**GE MONOGRAM REFRIGERATORS
WATER FILTER MODELS JANUARY 2000
SPECIAL PUSH ON CONNECTORS FOR
WATER LINE**

REF 06-00

JUNE 2000

CUT TUBING AT 90°

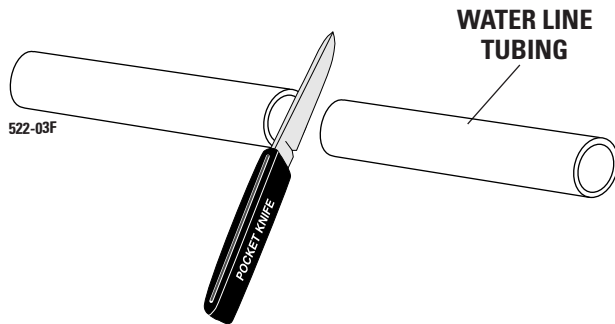
Monogram refrigerator water filter models manufactured in January 2000 have special connectors on the water valve. These connectors simplify installation of the water lines. When using these connectors, cut tubing off at **90°**.

WR02X10444

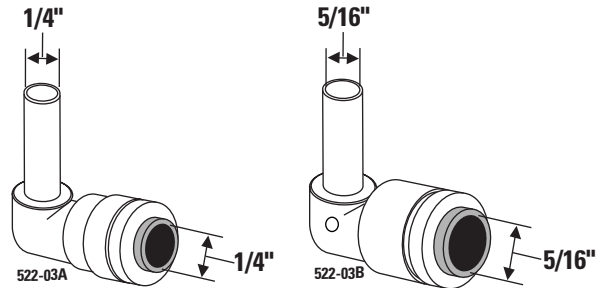
To connect, push straight and firmly into connector until connection is secure. To remove, hold collar of connector down and pull to release.
